<b>Project Title</b>	CTR Candeias Landfill Gas Project
<b>Project Reference</b>	1724.V1
<b>Report Date</b>	30 August 2011
<b>Client Name</b>	International Bank for Reconstruction and Development, as Trustee of the Spanish Carbon Fund (SCF)
<b>Client Address</b>	1818 H Street, NW Washington, DC 20433 USA

<b>Project Title:</b>	<b>CTR Candeias Landfill Gas Project</b>		
Project Location	Municipality of Jaboatão dos Guararapes in the Recife Metropolitan Area		
Country:	Brazil		
Project Parties	Brazil Kingdom of Spain (acting as direct participant)		
Project Participants	Haztec Tecnologia e Planejamento Ambiental SA International Bank for Reconstruction and Development, as Trustee of the Spanish Carbon Fund (SCF)		
Methodology used	ACM0001 "Consolidated baseline and monitoring methodology for landfill gas project activities"		
Methodology version number	11		
Estimated Annual Average Emission Reductions	155,112		
Crediting Period Dates	01 August 2011 to 31 July 2018		
GSP PDD Version	Date: 19 June 2009	Final PDD Version	Date: 08 March 2011
	Version Number: 01		Version Number: 10
	Start date of GSP: 07 October 2009

ERM CVS was commissioned by the World Bank Group (International Bank for

**Figure 1. Comparison of O&M costs of other similar registered projects generating electricity from landfill gas registered under methodology ACM0001, for which data is available**

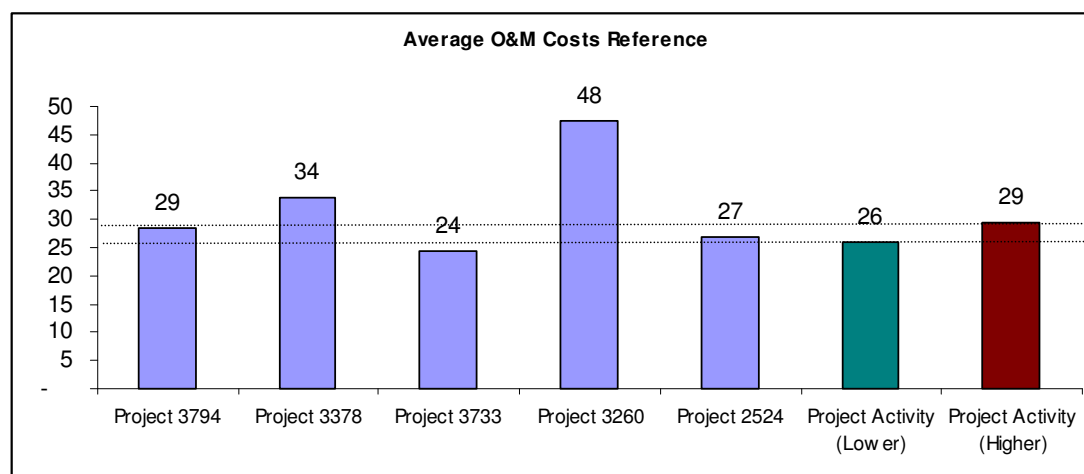
The comparison indicates that the O&M costs are reasonable compared to the range of costs observed on other similar projects that have recently been developed.

**Figure 2: Historical electricity prices for other generation sources in the northeast region of Brazil**

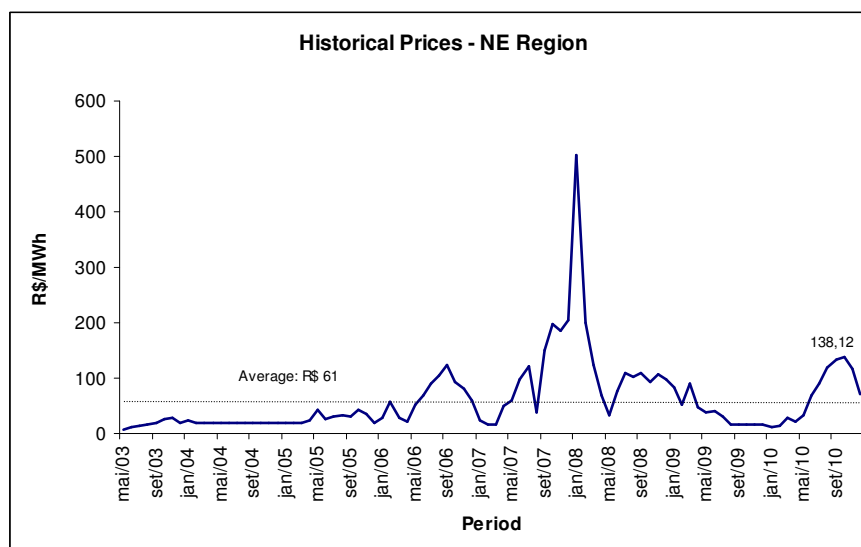
The price assumed for the electricity tariff is based on the latest available Alternative Energy Auction (R\$ 148.39/MWh) in Brazil dated on 26 August 2010, as described above. In order to reach the benchmark, the electricity tariff would have to be 13% higher than this. Electricity prices vary according to region, demand, generation type and power plant capacity. An auction for the kind of energy that is going to be sold by the PPs happened only twice, in 2007 and 2010. Therefore it is difficult to make assumptions on the tariff used in the project. However, considering the historical prices for all other sources of energy in Brazil's Northeast region it is possible to see that the price level assumed by the PPs is among the highest ones of the market (except for January 2008 prices, when the market went through a crisis due to a long period of very low rainfall). The historical electricity price for other generation sources in the northeast region of Brazil is presented in the graphic below, based on the database of the Electricity Energy Commercialization Bureau (CCEE - Câmara de Comercialização de Energia Elétrica) [DR49; DR59]. The average price paid to all power plants in the Northeast Region grid between 2003 and 2010 was R\$ 61/MWh, much lower than the electricity price assumed for the project activity financial analysis.
